ALERT SERVICE BULLETIN

SUBJECT: MAIN ROTOR DRIVE - Main Gear Box (MGB)

**Periodic check of MGB magnetic plugs,
and replacement of MGB planet gears**

Revision No.	Date of issue
Revision 0	2017-06-13
Revision 1	2017-06-30
Revision 2	2017-11-14

3.B.2. Check of MGB magnetic plugs

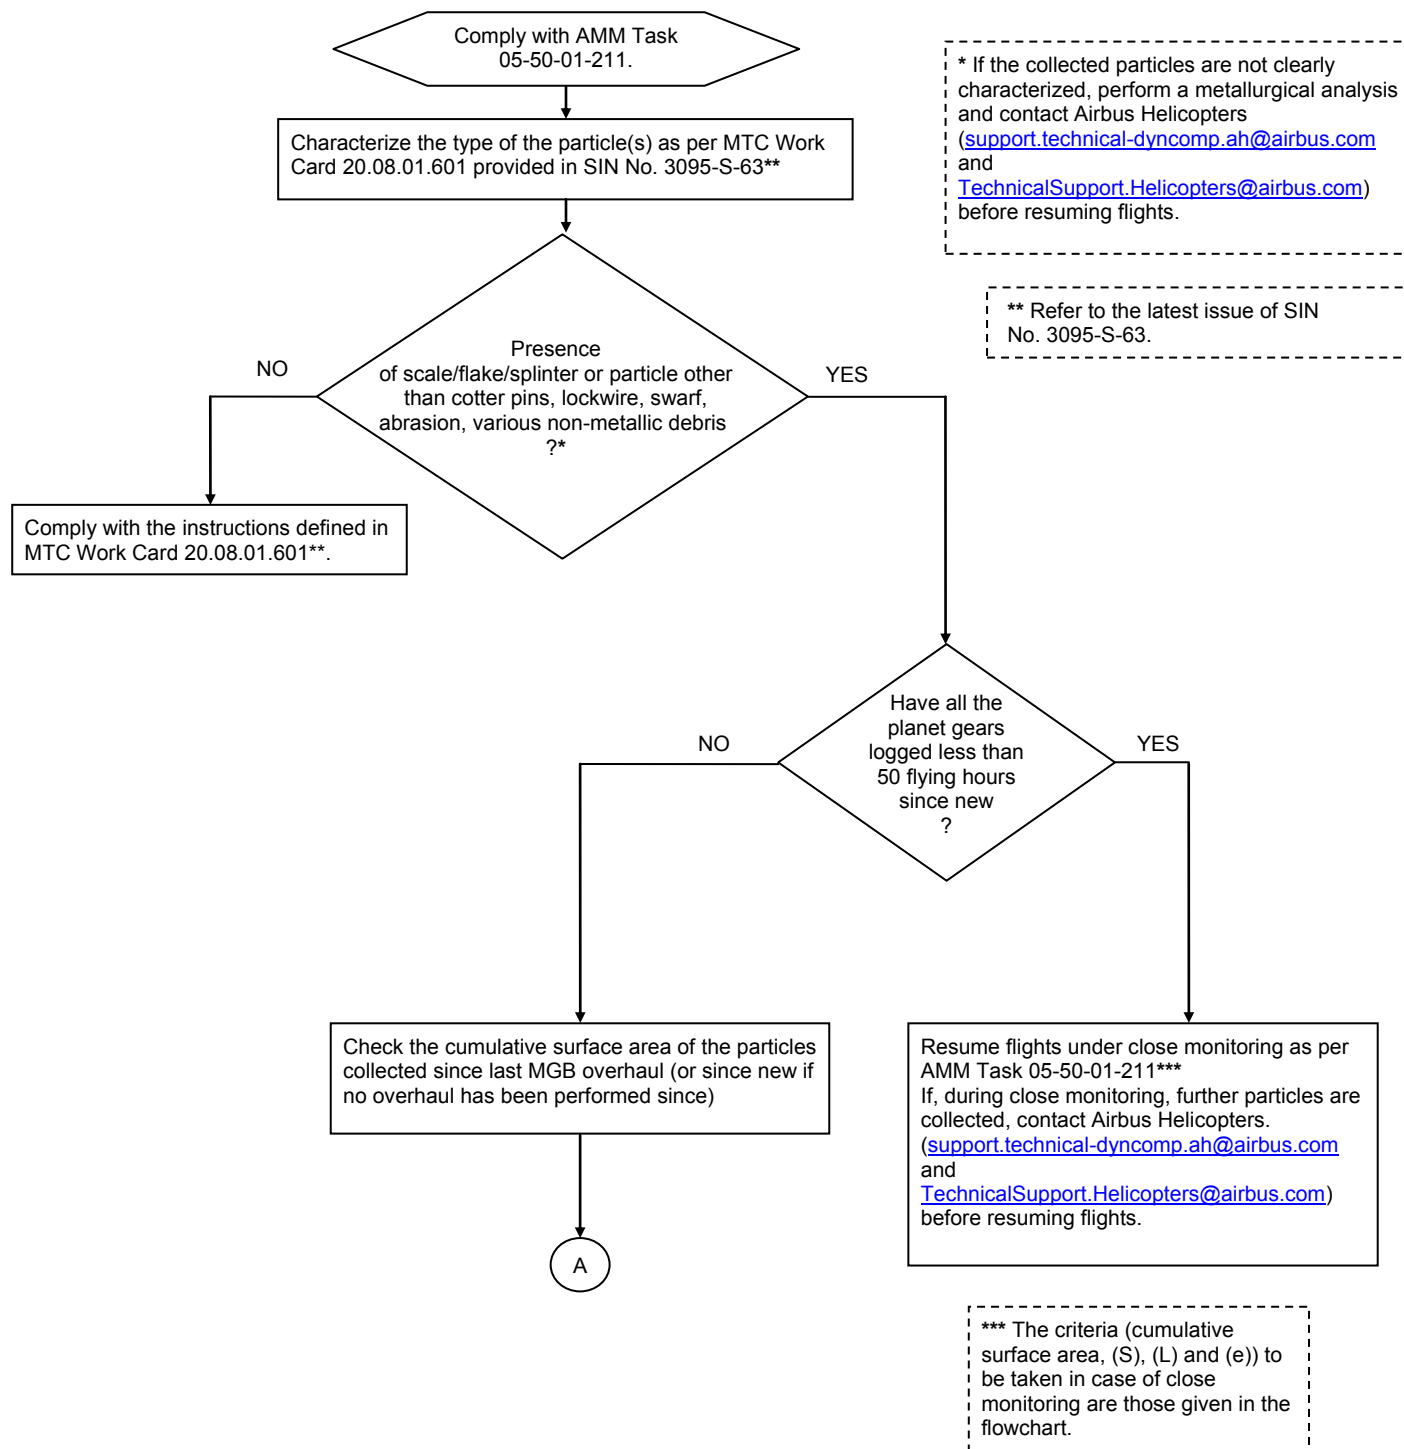
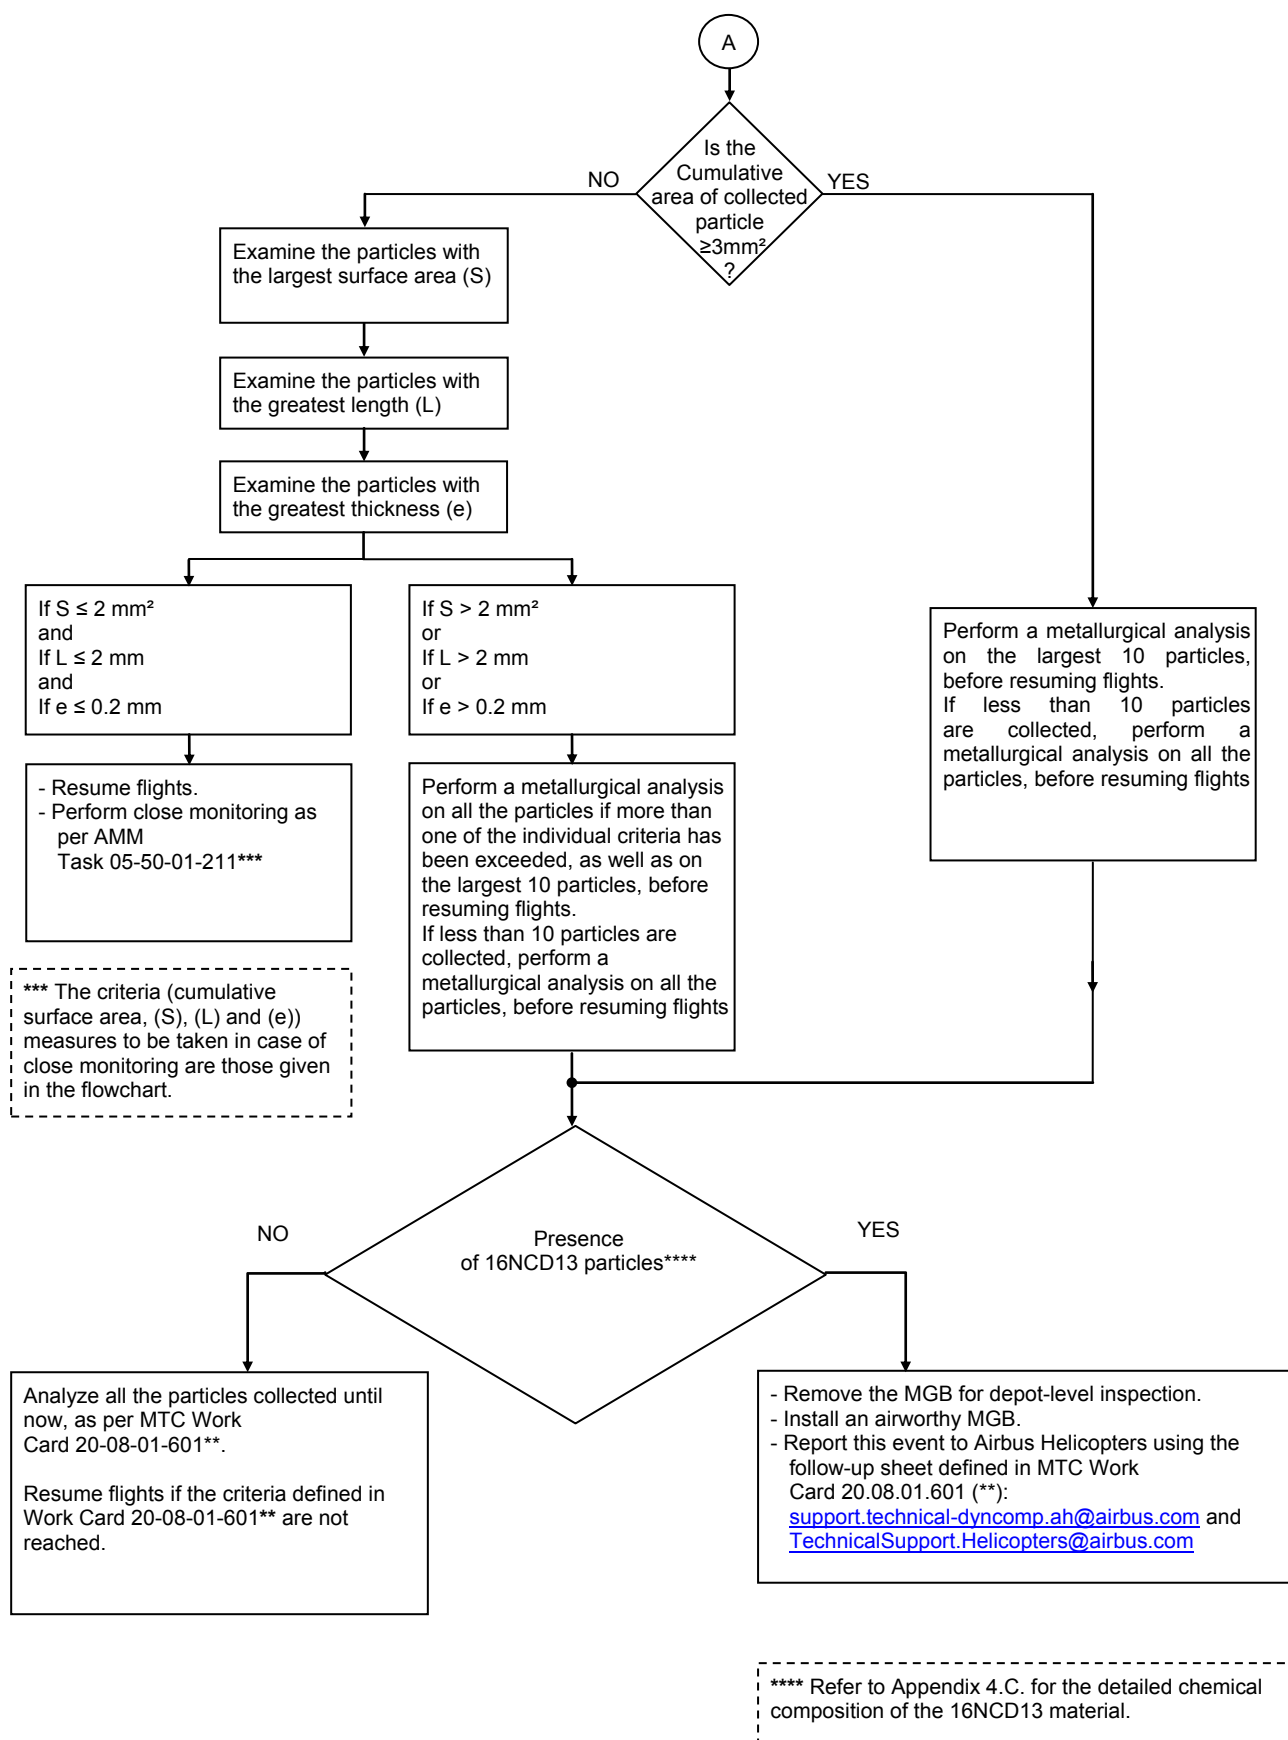
Check that there are no particles on the two magnetic plugs at the lower part of the MGB, as per AMM Task 63-40-02-211.

- a) If there are no particles:
 - Install the magnetic plug and resume flights.
- b) If there are particles:
 - Refer to the following flowchart.
